Project Name	BCWD Permit 23-02, Tweden Residence "White Oak Savanna Block 2 Lot 7"	Date	01/08/2024
To / Contact info	Karen Kill / BCWD Administrator		
Cc / Contact info	Jennifer Cates / Cates Fine Homes, Inc.		
Cc / Contact info	Randal Tweden		
From / Contact info	Ryan Fleming, PE / EOR John Sarafolean, EOR		
Regarding	Permit Amendment Engineer's Report

Recommendation: Consider approval based on the variance analysis herein

Figure 1: Annotated schematic of Block 2 Lot 7 from Permit 17-01 approved plan

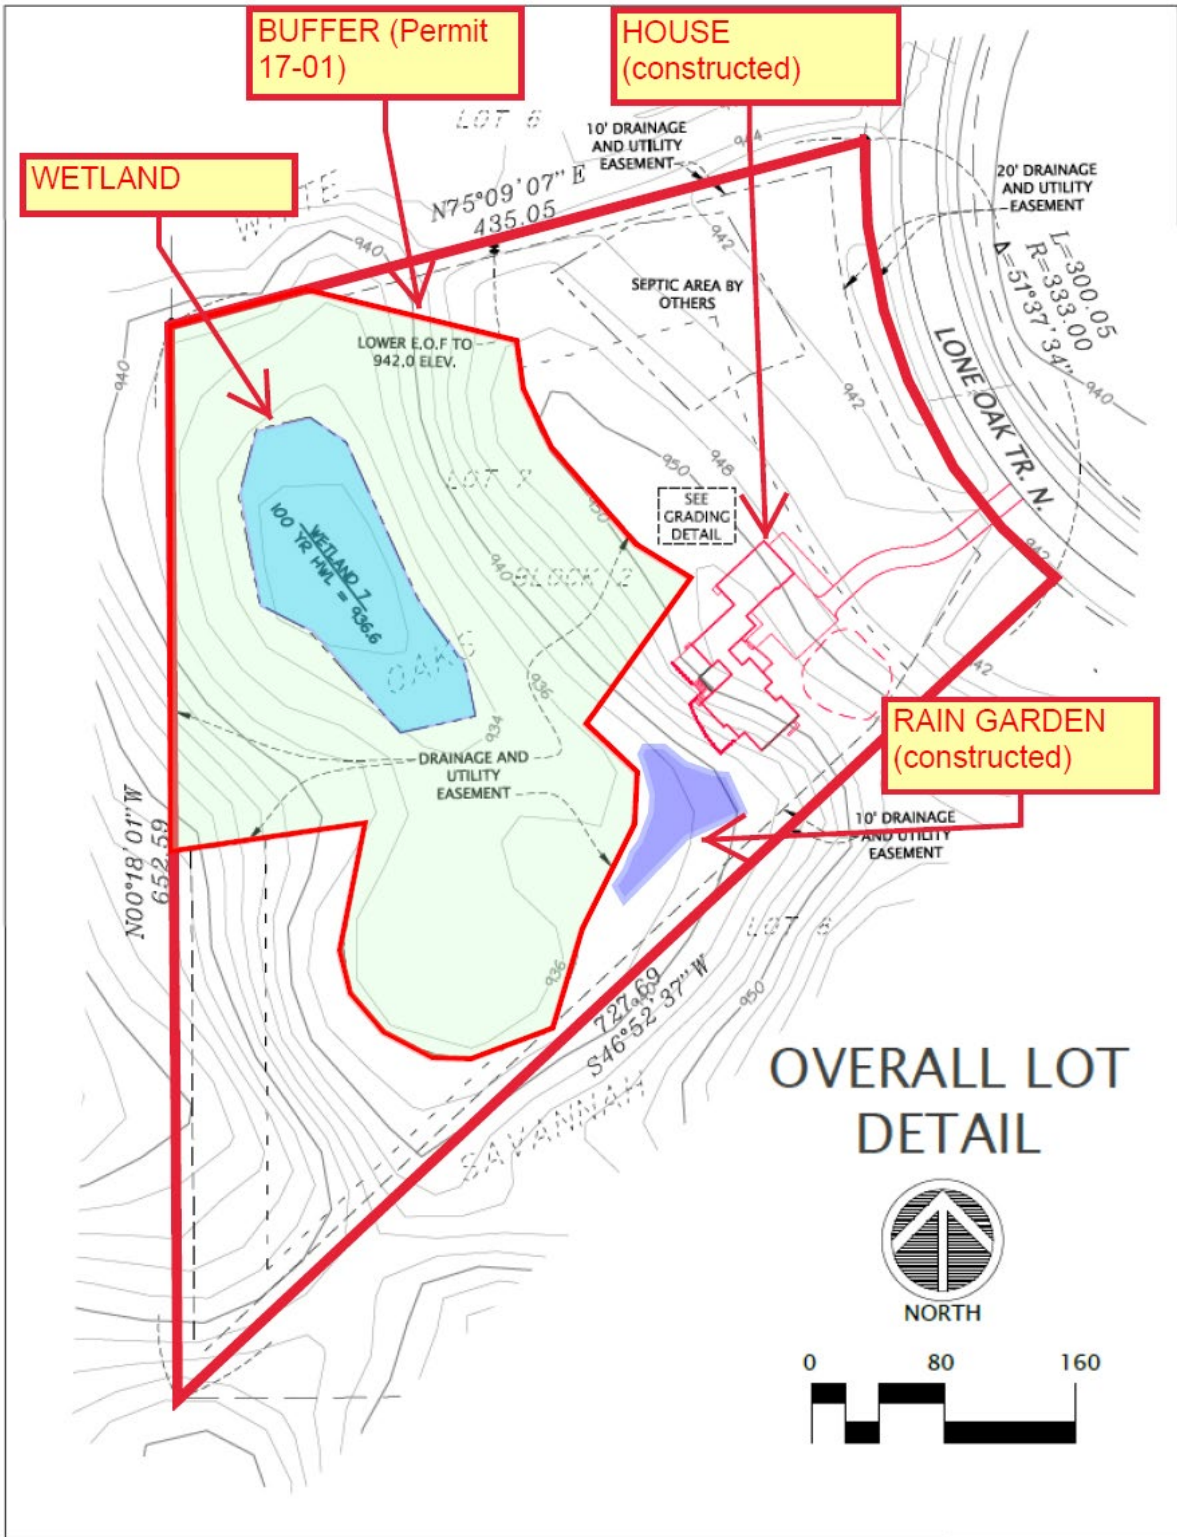
As shown in Figure 1, Wetland #7 and the associated wetland buffer cover 2.3 acres of this lot. This area includes the buffer that is protected by a maintenance declaration that was recorded on the property in compliance with Permit 17-01; the buffer area is shown in green. All permit conditions were met prior to construction and the permit is in good standing. Construction of the home and rain garden is complete with only the final landscaping and turf establishment remaining to be completed. The BCWD permit 23-02 is active and the district is currently holding \$19,995 in financial assurance associated with the grading alteration and stormwater facility construction.

Figure 2: Proposed solar panel layout

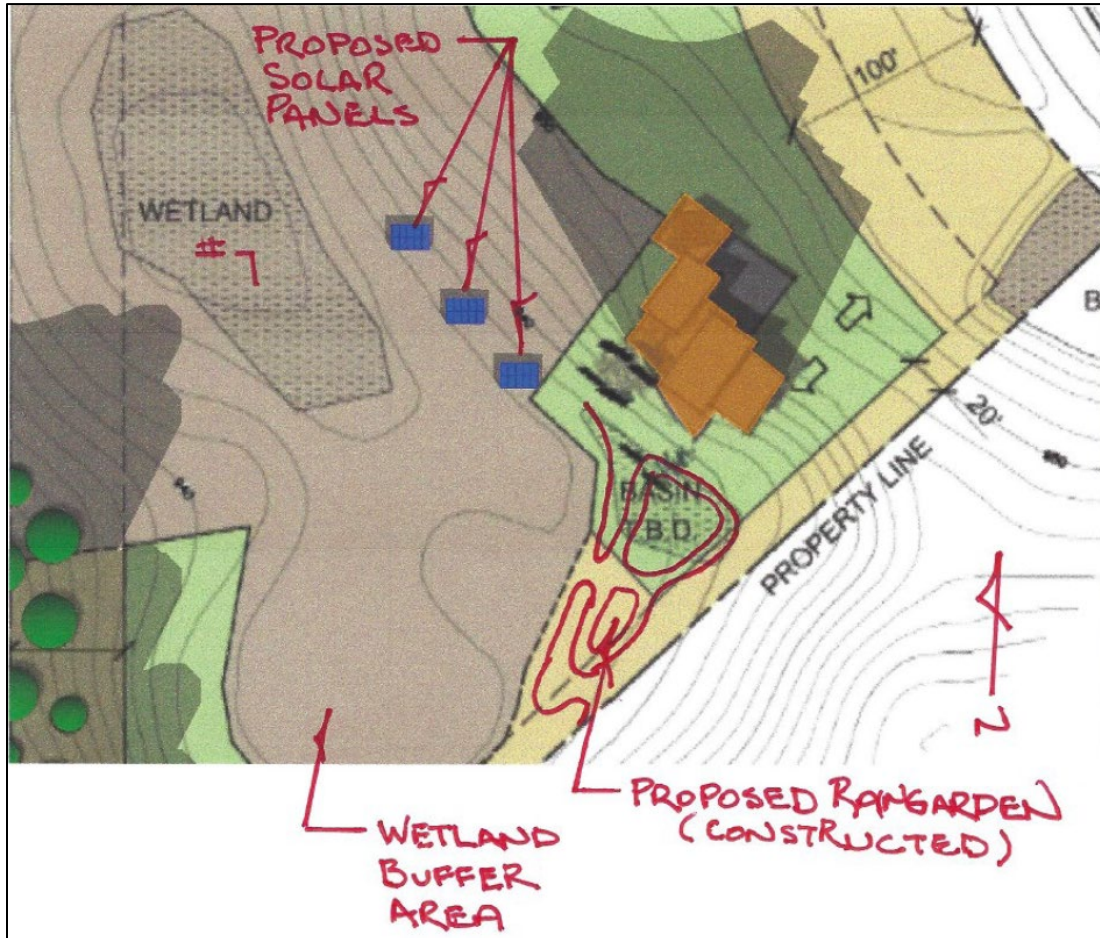
The applicant is requesting an amendment to the permit for installation of three ground-mounted solar panels totaling 665 square feet of impervious area southwest of the house in the wetland buffer as shown in Figure 2. The applicant is requesting a variance from compliance with subsection 4.4.2, which prohibits the creation of impervious cover within a wetland buffer.

The proposed location of the solar panels on the property is within wetland buffer protected by a recorded declaration under permit 17-01. Per the declaration, the proposed activity of installing solar panels is prohibited in the buffer as it does not comply with 4.4.2 subsections a and e of the rule.

Rule 4.4.2(a) & (e) Limitations in Buffer Zones: Wetland #7 is located on the Tweden Residence at 7211 Lone Oak Trail in Grant. The property is a part of the White Oaks Savanna development and the wetland buffer on the property in review was recorded in the maintenance declaration with the development in 2018. The applicant is proposing to install a solar system consisting of three ground mounted solar panel arrays (groups) on the property within the recorded wetland buffer area. The solar panel groups constitute a utility, and their installation will create 665 square feet of impervious

cover within the 86,792 square foot buffer, which is prohibited by the declaration (BCWD Rule 4.4.2). The panel location is shown in Figure 2, just west of the wetland positioned outside of the 100-yr HWL of the wetland.

- 3-1. Submit an amended erosion control site plan for the property including any erosion control and restoration measures needed for the installation of the solar panels. (BCWD 3.2.2).

Figure 4: Solar panel design and dimensions.

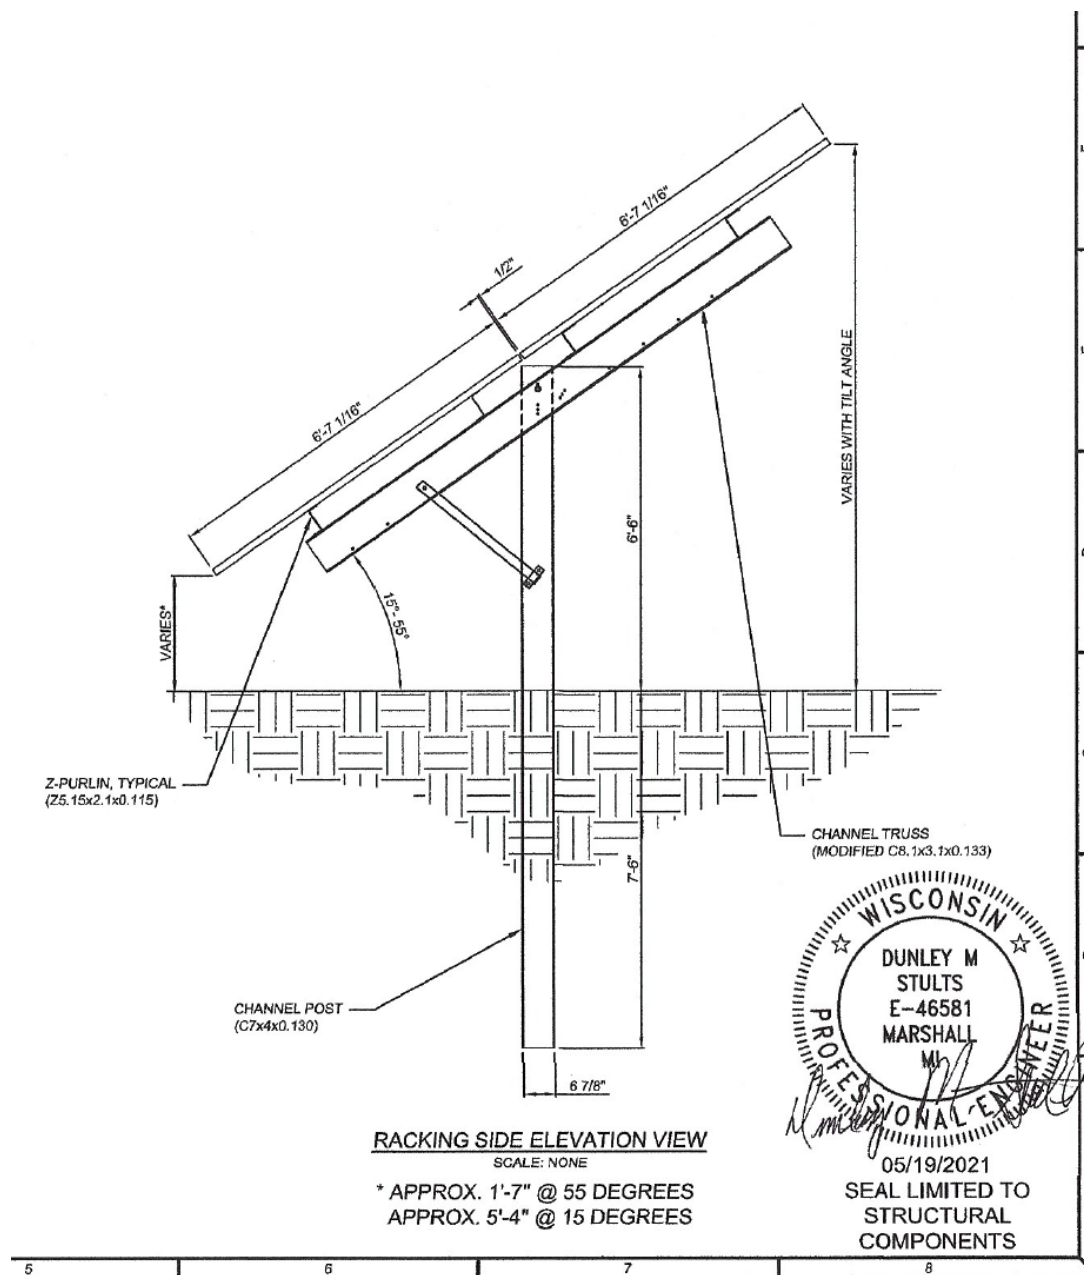
in the buffer and the shading from the panels and the racking posts will not hinder the vegetation from filtering and using the available water for evapotranspiration. Due to the design of the panels sitting on posts off the ground, there will be no disconnection between the vegetation allowing it to function as it would without the panels there.

Hydrologic event modification (Flow rate and volume alteration) – Concentrated flow from the panels will be created where water runs off at the drip line of the panels, however, the area of impact from this flow represents less than 1 percent of the 86,792 square foot buffer area. According to the Minnesota Stormwater Manual Fact Sheet on stormwater guidance for solar farm projects, the MPCA strongly recommends that the lowest vertical clearance of any solar array be no greater than 10 feet in order to prevent/control erosion and scour along the dripline. This recommendation will be followed as the plan calls for the racking to be 6'6" where it meets the middle of the underside of the panel shown in Figure 4. With respect to volume of runoff from the impervious in the buffer, the applicant oversized the rain garden capturing runoff from the house and yard to account for the additional impervious area of the solar panels. While the panels do not drain to the rain garden, the additional capacity in the rain garden will result in more volume retention and pollutant treatment from the home site annually since discharge from the rain garden to the wetland will be less frequent than if the rain garden were to have been sized to just meet the stormwater standard.

Aquatic and terrestrial wildlife habitat – The habitat of the buffer vegetation will not be affected by the installation of the solar panels because of the nature of the design. The solar panels are going to be off the ground on posts and will offer an alternative habitat to wildlife such as birds and insects in the shade of the panels and the existing vegetation will remain. Increased shading will not hinder buffer vegetation robustness –a solar study finds that vegetation growth is not hindered and is often helped beneath solar panels (Nordberg, E. J., Julian Caley, M., & Schwarzkopf, L. (2021). Designing solar farms for synergistic commercial and conservation outcomes.). In another finding, the Shell company partnered with groups in the Netherlands to achieve energy transition and climate agreement rules.

The study found that solar parks can be suitable habitat for pollinators and that the average plant coverage, height, and number of species did not differ significantly between the sun and shaded areas. Also, the three sets of panels will be spaced sufficiently allowing for animal passage between panel groups.
